Historic Preservation Board

Wednesday, November 15, 2023 at 5:00 PM

- i. Administrative Appeal of Certificate of Appropriateness for Alterations to Noncontributing Garage; 14 ORCHARD STREET; William & Jean Bennett, Appellants. Plan Number: HPAR-002615-2023.

**STAFF MEMORANDUM
HISTORIC PRESERVATION PROGRAM
PLANNING AND URBAN DEVELOPMENT**

DRAWING NUMBER
A3.10

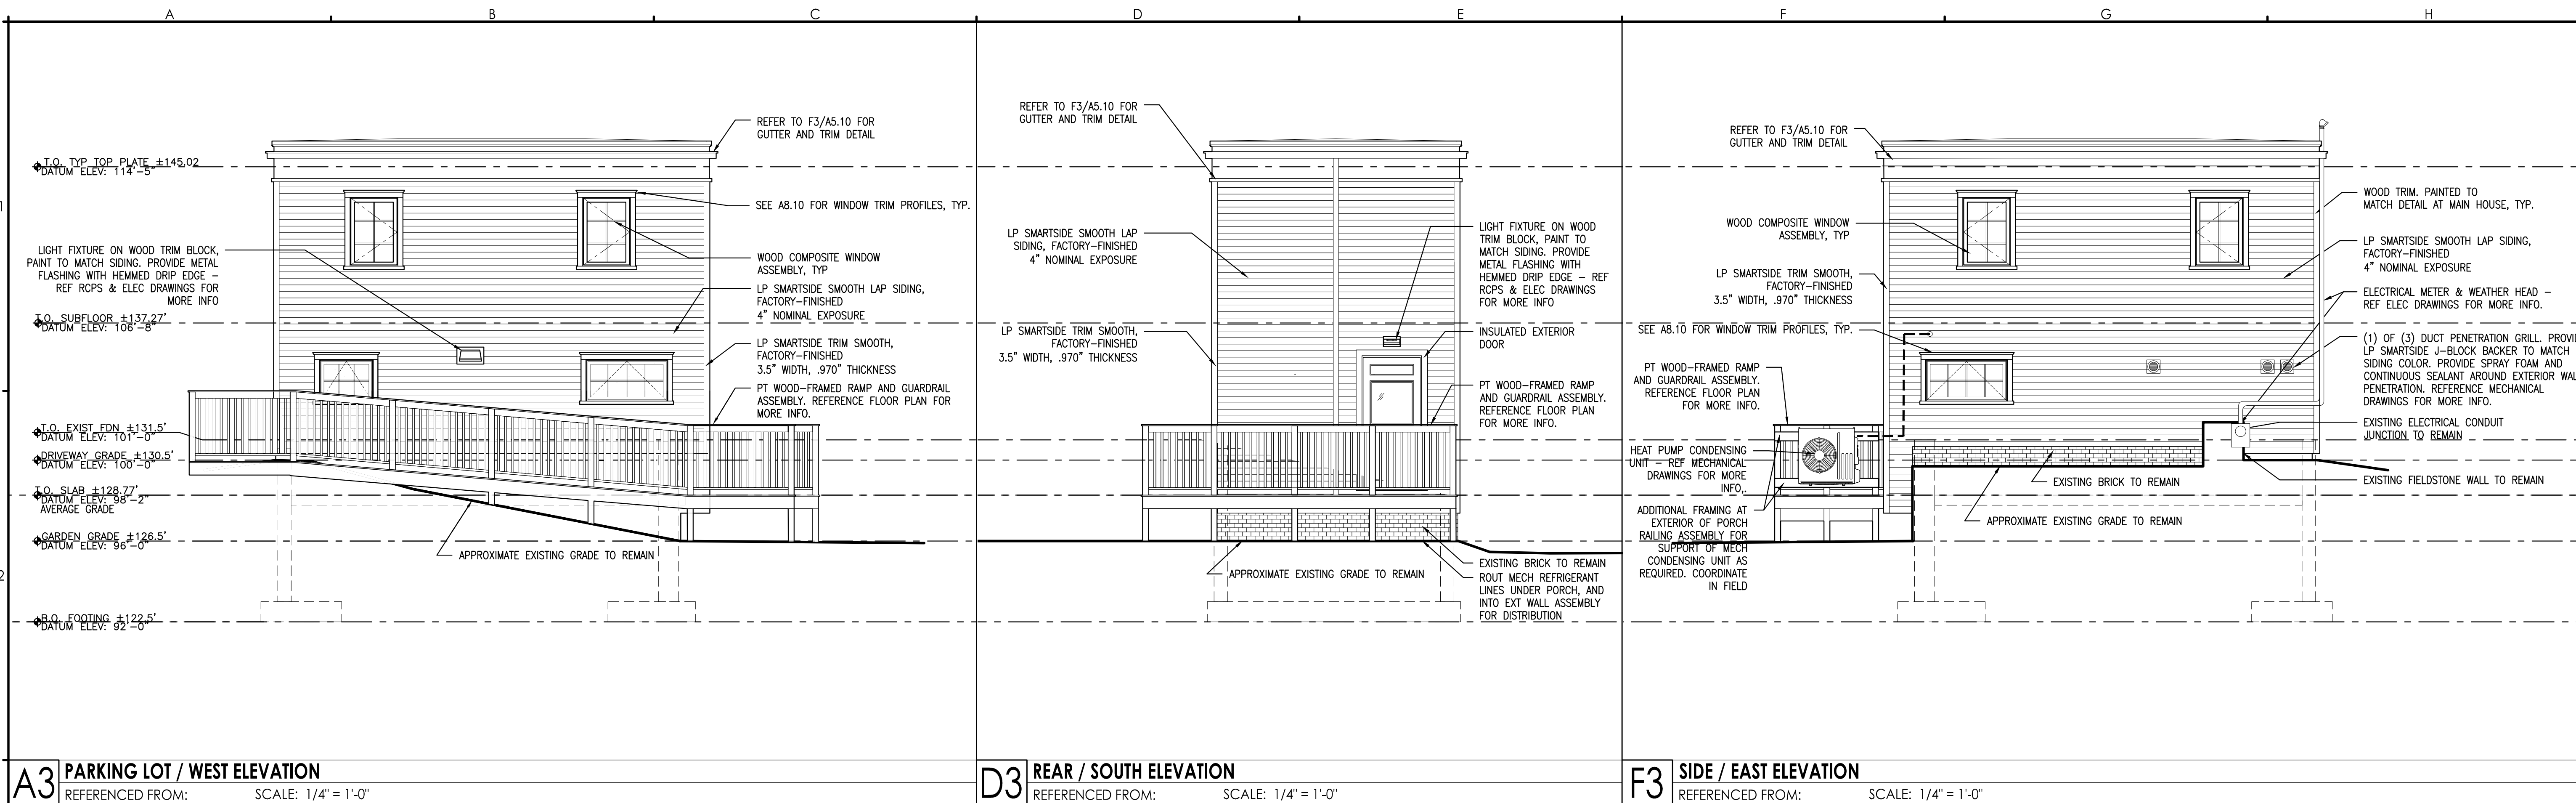
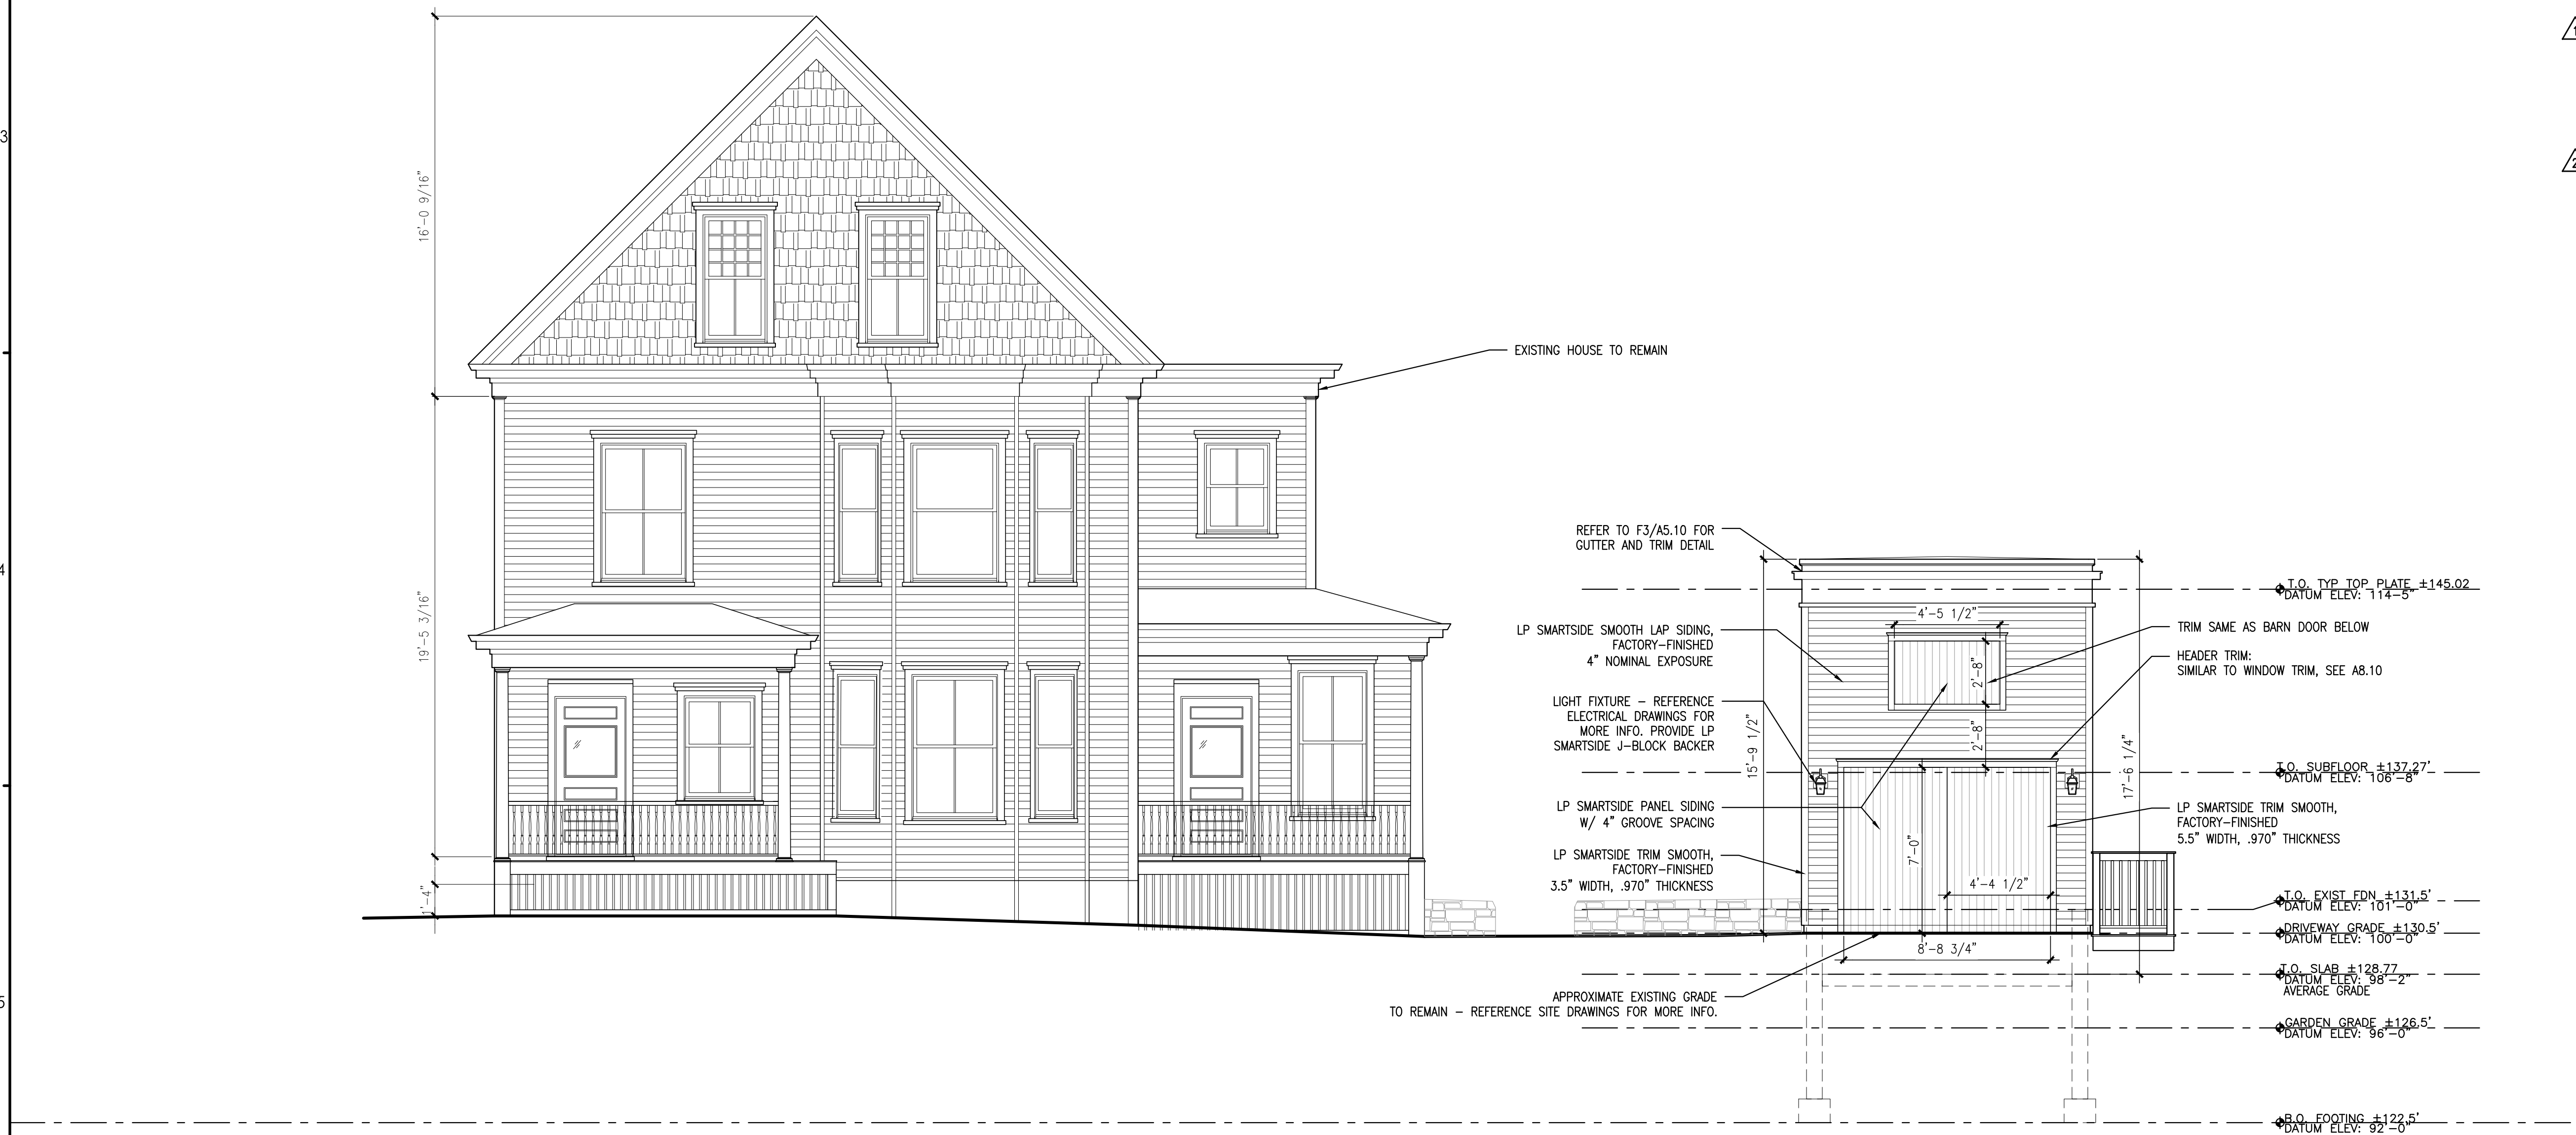
△ REVISED TO INCORPORATE COMMENTS FROM HISTORIC APPROPRIATENESS REVIEW.
